**2011 FIVE-YEAR REMEDY REVIEW
ACC 4-BASE PBC**

**MOUNTAIN HOME AIR FORCE BASE,
IDAHO**

September 2011

**REVISED FINAL
2011 FIVE-YEAR REMEDY REVIEW REPORT
ACC 4-BASE PBC
MOUNTAIN HOME AIR FORCE BASE, IDAHO
September 29, 2011**

ERP SITE LOCATION MAP MOUNTAIN HOME AIR FORCE BASE, IDAHO			
DRN. BY: DPG	DATE: 02/07/11	PROJECT NO. 16169962	FIG. NO. 1-2
CHK'D. BY: KAS	REVISION: 0

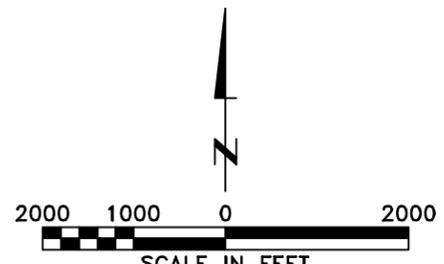
3. Figure 1-2 should also be cited in the Executive Summary and Section 4 (Remedial Actions). Figure 2 from the 1995 ROD was helpful in that it identifies the 33 sites with a brief description. Can a similar legend be included on figure 1-2? In any case, OU-3 regional groundwater is not listed as one of the 33 sites. Greater clarity is needed in terms of the scope of the Five Year Review (See specific comments on Section4).

Response: **Agree.** Figure 1-2 will be cited under the Purpose and Scope section of the Executive Summary. In addition, a legend identifying the site numbers and site names will be added to Figure 1-2 as suggested. While OU-3 regional groundwater will not be outlined on Figure 1-2 since it encompasses all groundwater at Mountain Home AFB, it will be added to the legend. Figure 1-2 will also be referenced in the first paragraph of Section 4.
